file location: S:\7068 DoE\7068WA01 North Sydney Public School Upgrade\02 DRAWINGS\1. ArchiCAD Files\7068WA01 - North Sydney Public School Upgrade - SD Archive 1 SEC 4.55 MOD 3.pln

SEC. 4.55 MODIFICATION (NO. 3) ITEMS

Application No: SSD-11869481-Mod-3 Granted: 22 December 2023

- NORTH SYDNEY PUBLIC
- SCHOOL

BUILDING J - LEVEL 1 FLOOR | Figured dimensions take precedence over scale dimensions. Contractors must verify

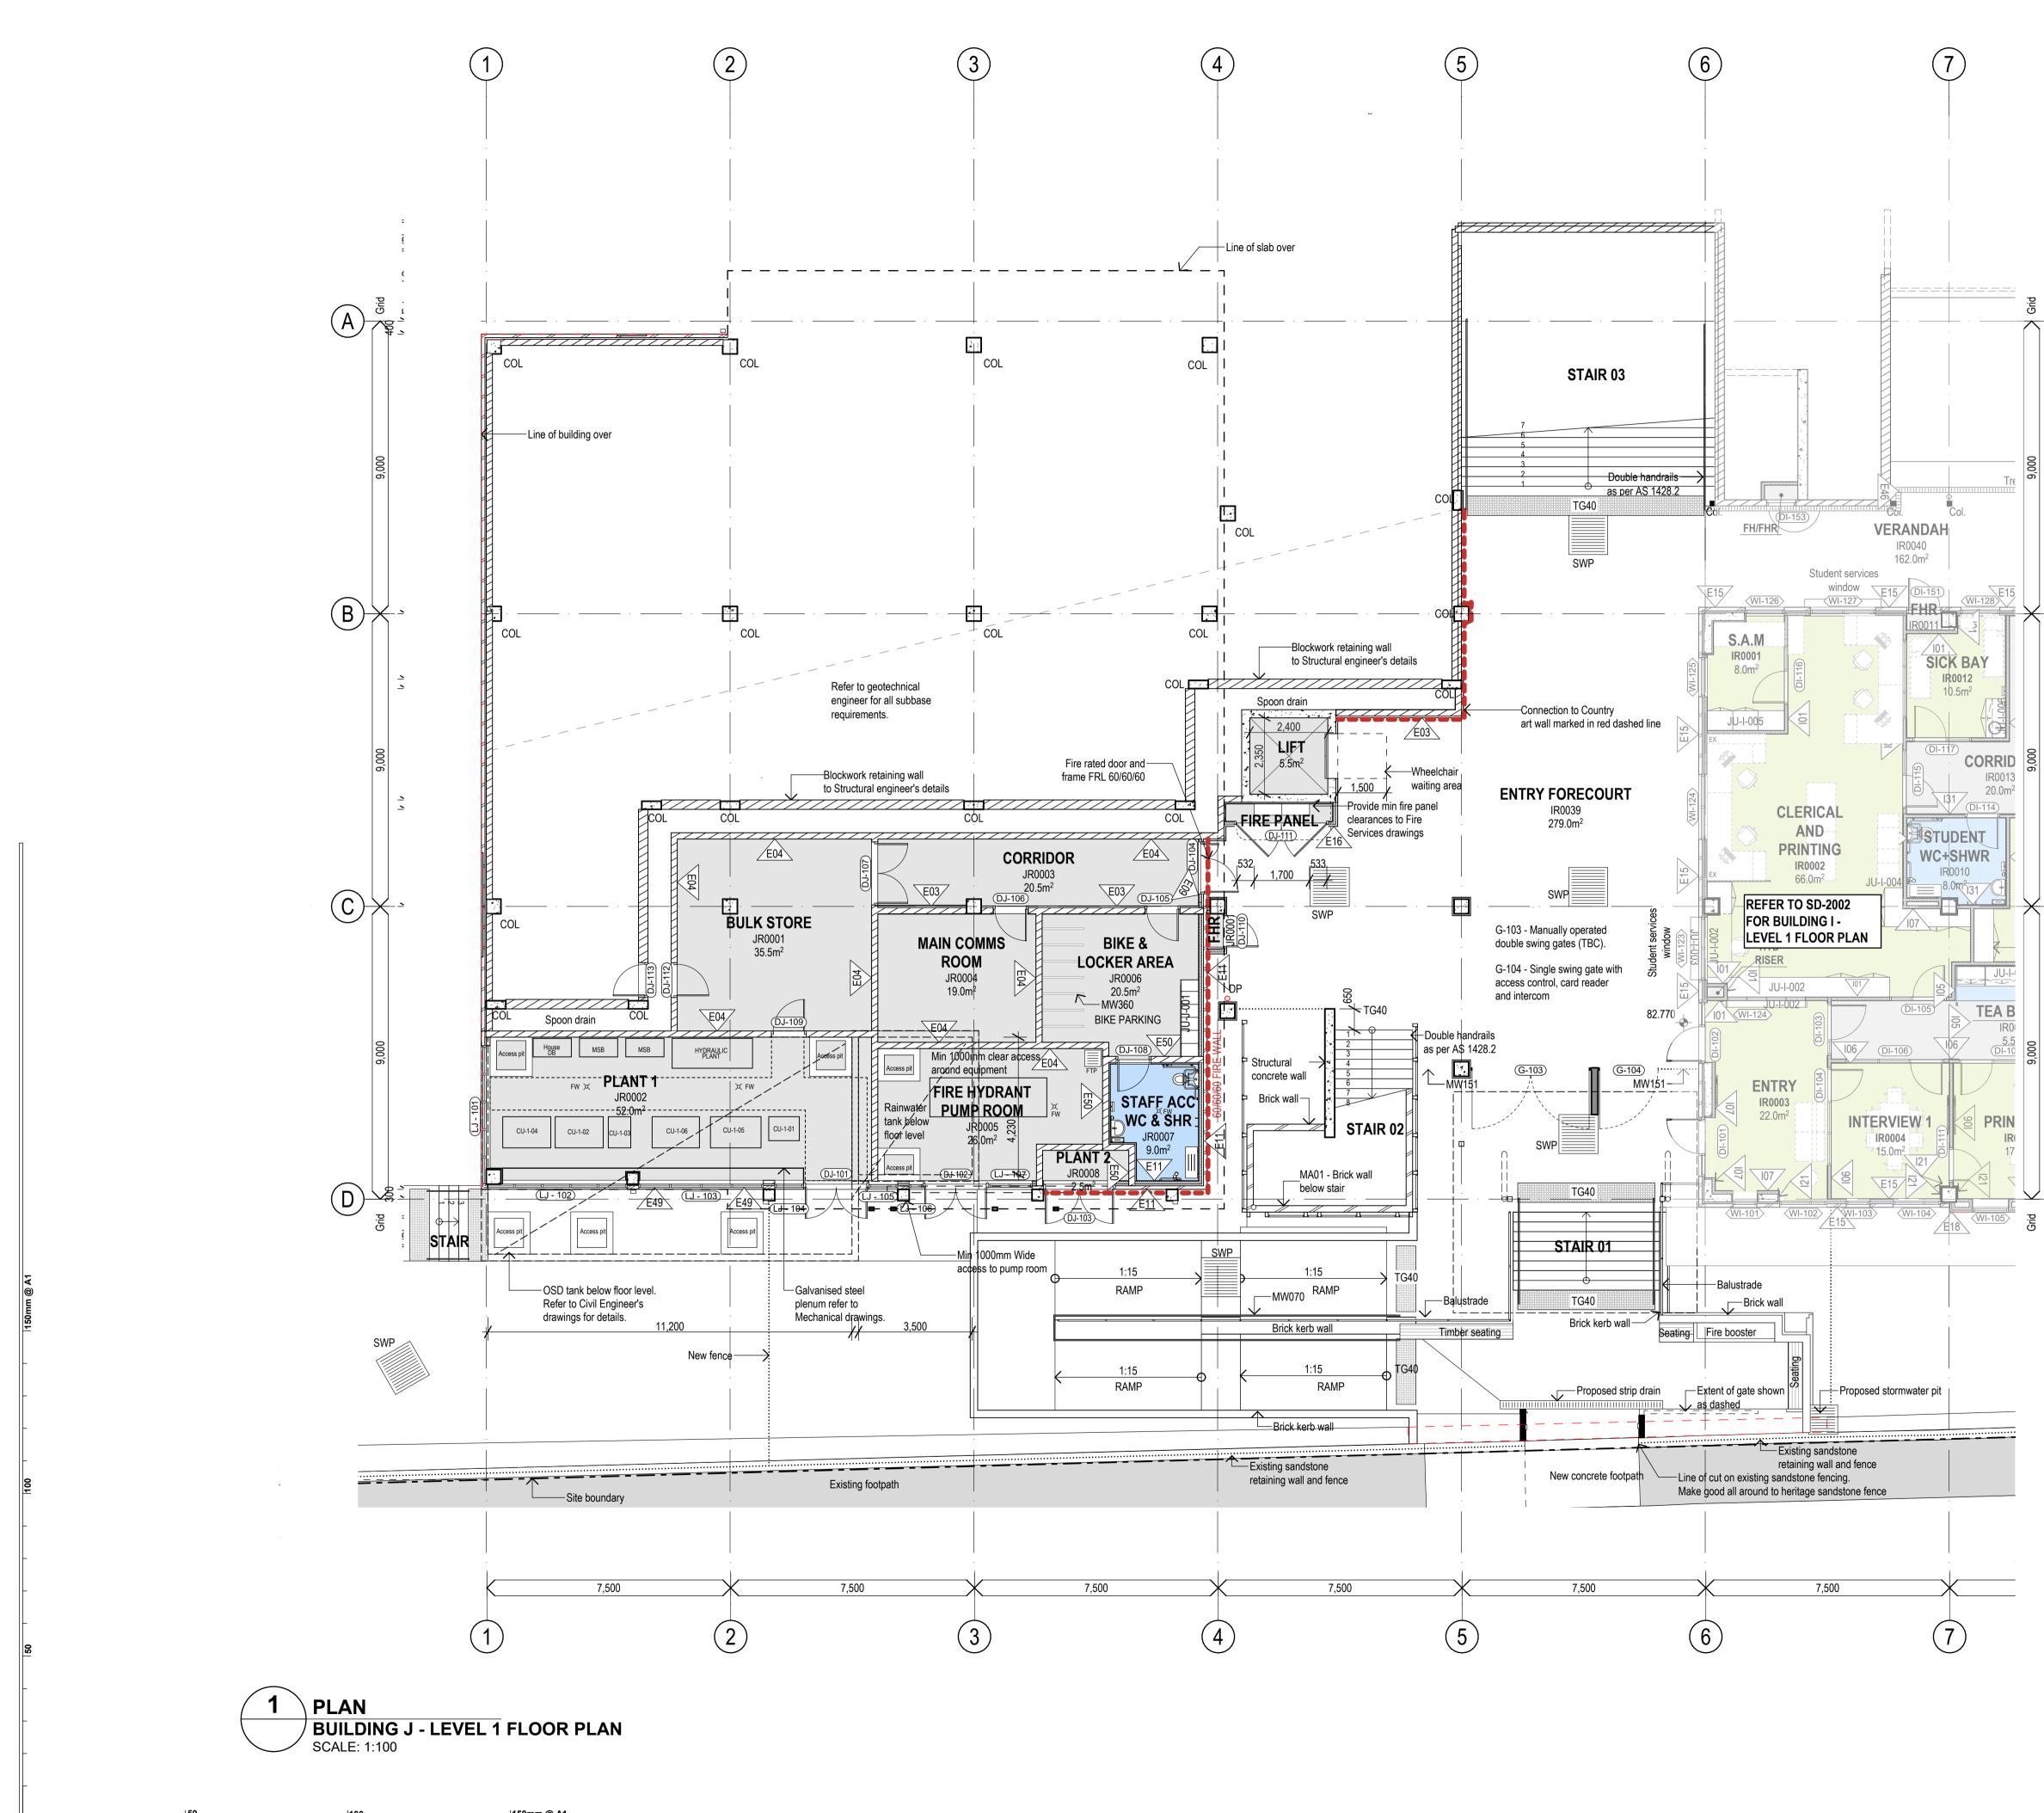
ON PLAYGROUND SOUTH OF BUILDING F) 12 REPAIRS TO SECTION OF HERITAGE FENCE 13 CHANGES TO SOLAR PANELS

- LANDSCAPE CHANGES (NEW LOCATION OF YARNING CIRCLE) LANDSCAPE CHANGES (LOCATION OF BIKE PARKING)
- CHANGE TO BLEACHER RETAINING WALL TO
- ACCOMODATE EXISTING SHADE SAIL FOOTING 4 LANDSCAPE CHANGES (PLAY EQUIPMENT)
- LANDSCAPE CHANGES (TIMBER DECKING)
- NEW ALUM WINDOWS TO MULTIPURPOSE ROOMS. 1650MM WINDOW HEIGHT WITH SILLS AT 750MM AFFL.
- TENSILE MESH ABOVE 1300 AFFL TO UNDERSIDE OF SLAB/ROOF

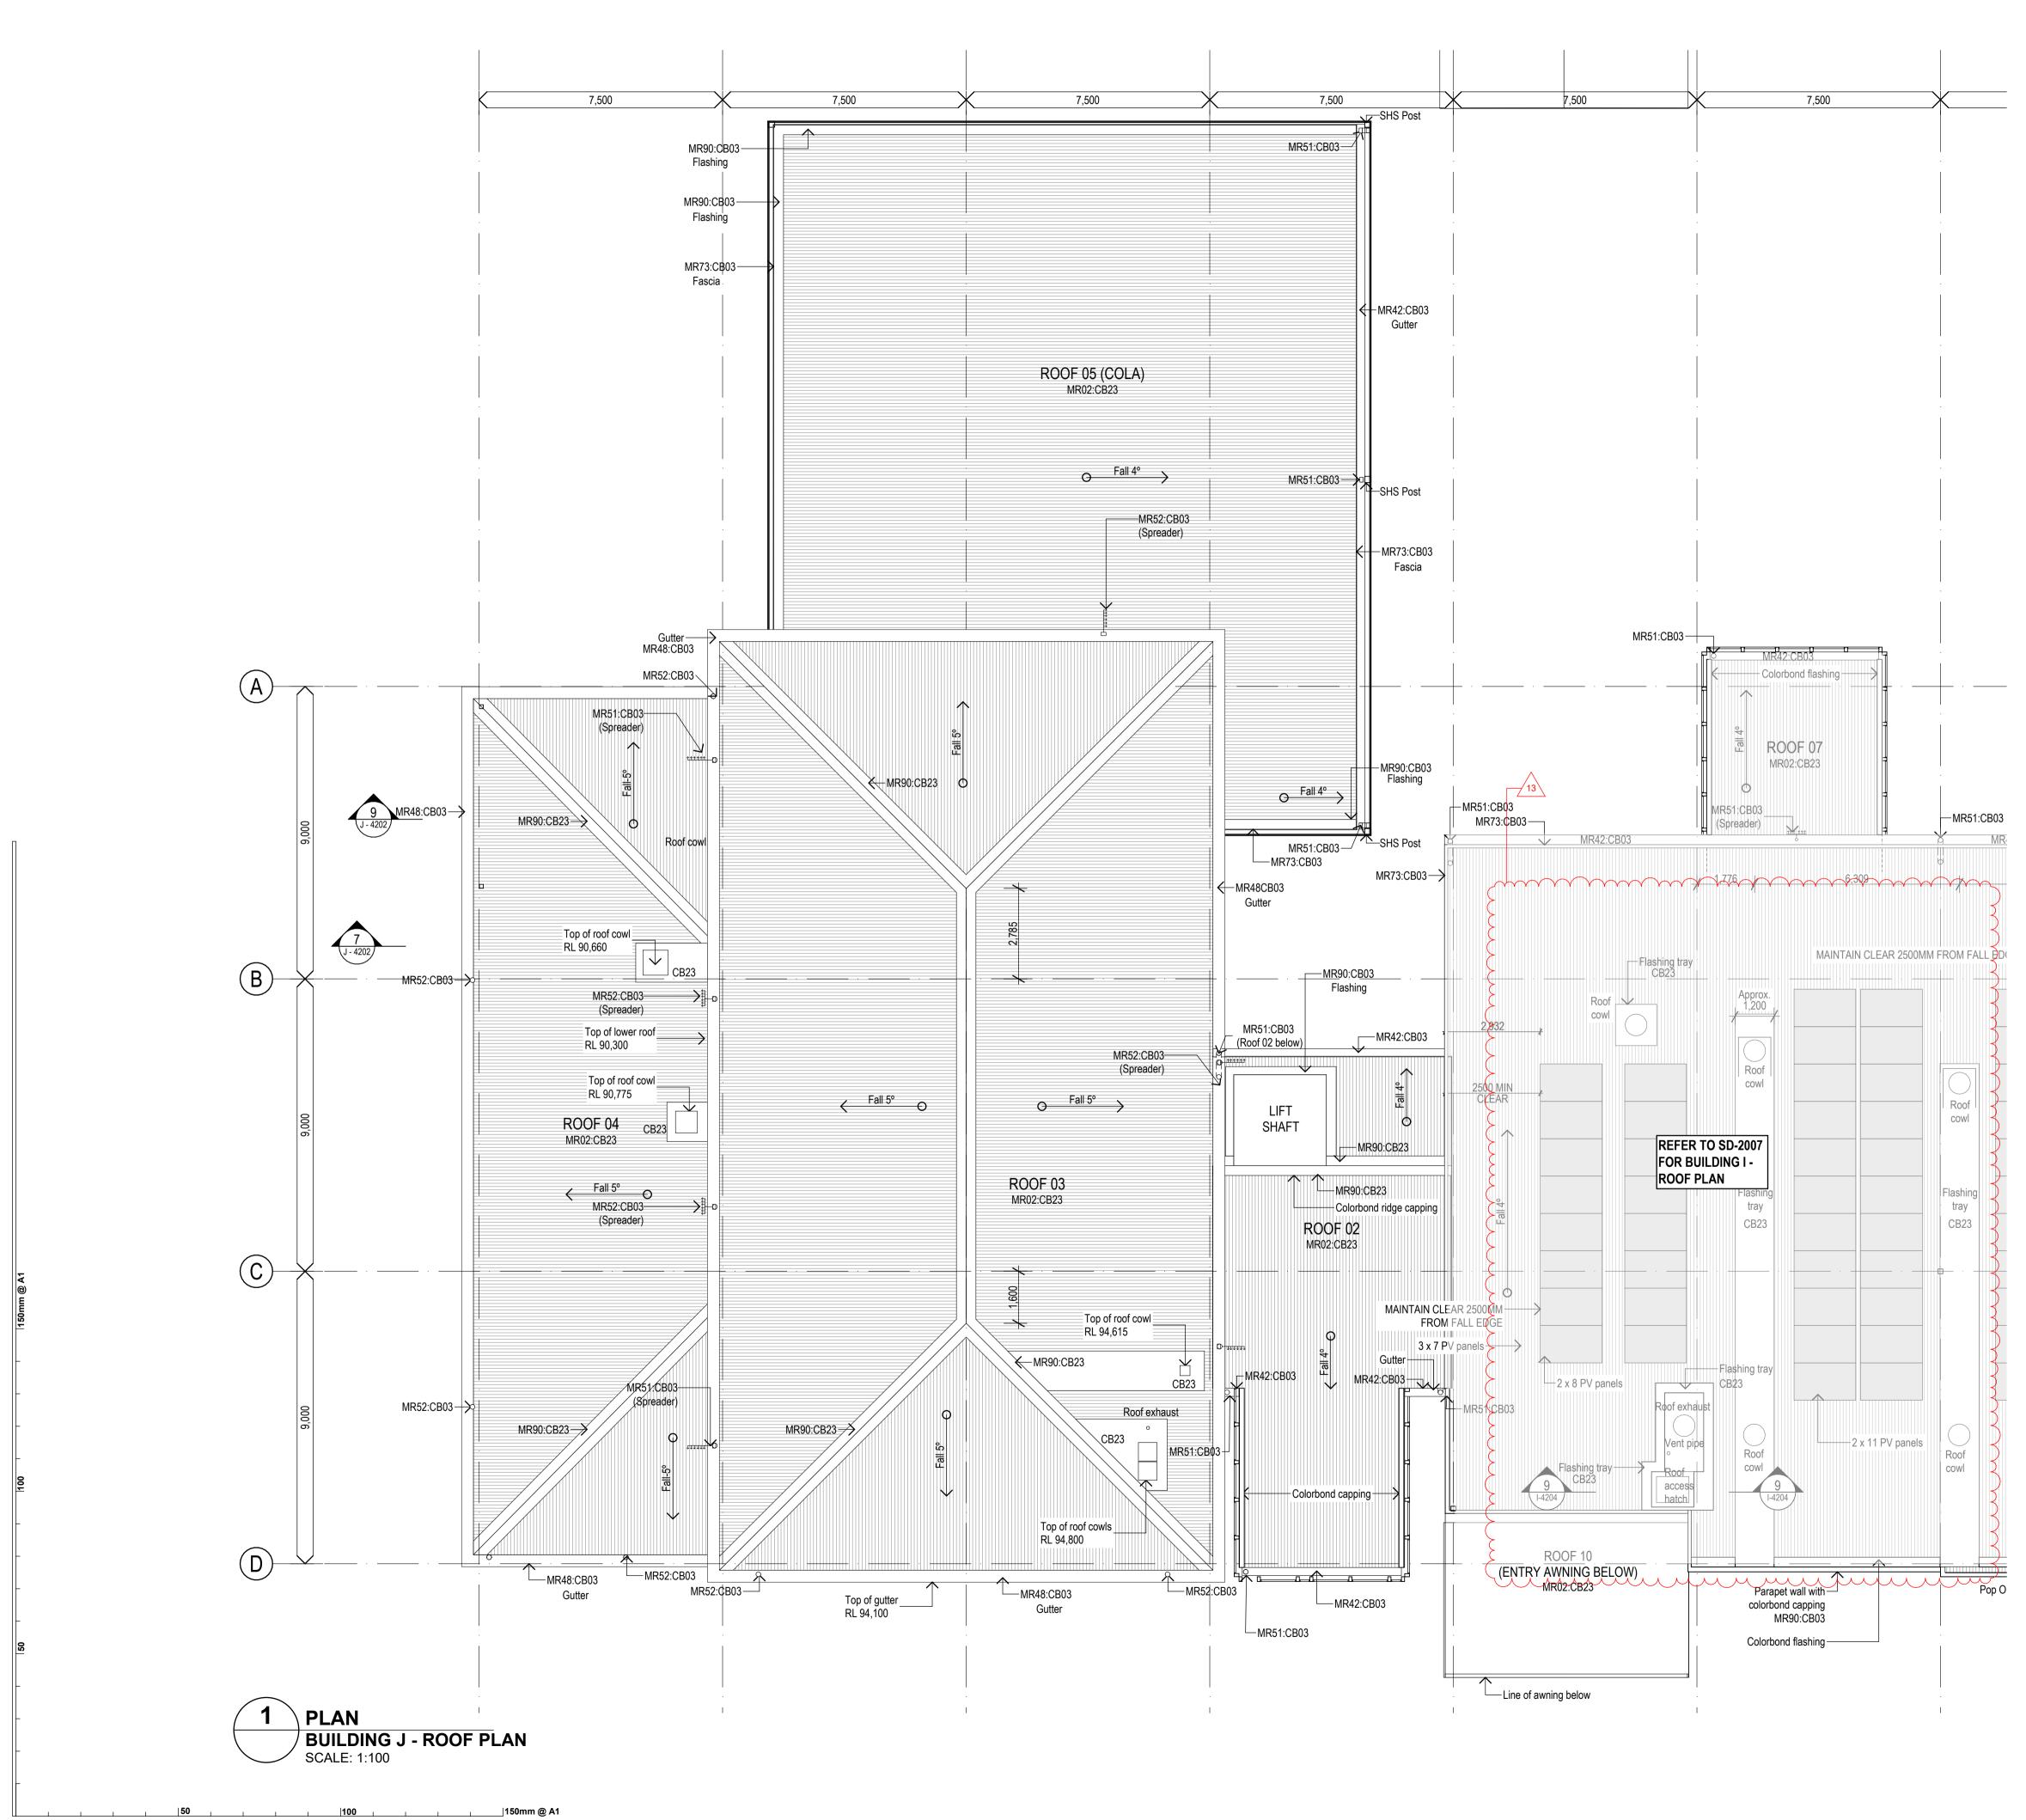
Copyright This drawing shows design features and elements of a design prepared by Fulton Trotter Architects and is to be used only for work authorised in writing by the designers. It cannot be copied directly or indirectly, in whole or in part, nor shall it be used for any other building purposes. Unauthorised use will be considered an infringement of these rights. **ROOF PLAN LEGEND** ROOF LABEL ROOF 1← ROOF NUMBER XX00 : XX00 FINISH CODE (REFER TO FINISHES LEGEND) MATERIAL CODE (REFER TO MATERIAL LEGEND) $\ominus^{\text{FALL 5}}$ FALL IN ROOF _____ SEC. 4.55 MODIFICATION (NO. 3) ITEMS LANDSCAPE CHANGES (NEW LOCATION OF YARNING CIRCLE) 2 LANDSCAPE CHANGES (LOCATION OF BIKE PARKING) CHANGE TO BLEACHER RETAINING WALL TO ACCOMODATE EXISTING SHADE SAIL FOOTING 4 LANDSCAPE CHANGES (PLAY EQUIPMENT) 5 LANDSCAPE CHANGES (TIMBER DECKING) 6 NEW ALUM WINDOWS TO MULTIPURPOSE ROOMS. 1650MM WINDOW HEIGHT WITH SILLS AT 750MM AFFL. TENSILE MESH ABOVE 1300 AFFL TO UNDERSIDE OF SLAB/ROOF /P_ 8 CHANGES TO THE CONFIGURATION OF STAIR 08 9 LANDSCAPE CHANGES (2 STAINLESS STEEL BENCHES ON PLAYGROUND WEST OF BUILDING J) 10 LANDSCAPE CHANGES (WHALE LINE MARKING) 11 LANDSCAPE CHANGES (4 STAINLESS STEEL BENCHES ON PLAYGROUND SOUTH OF BUILDING F) 12 REPAIRS TO SECTION OF HERITAGE FENCE

13 CHANGES TO SOLAR PANELS
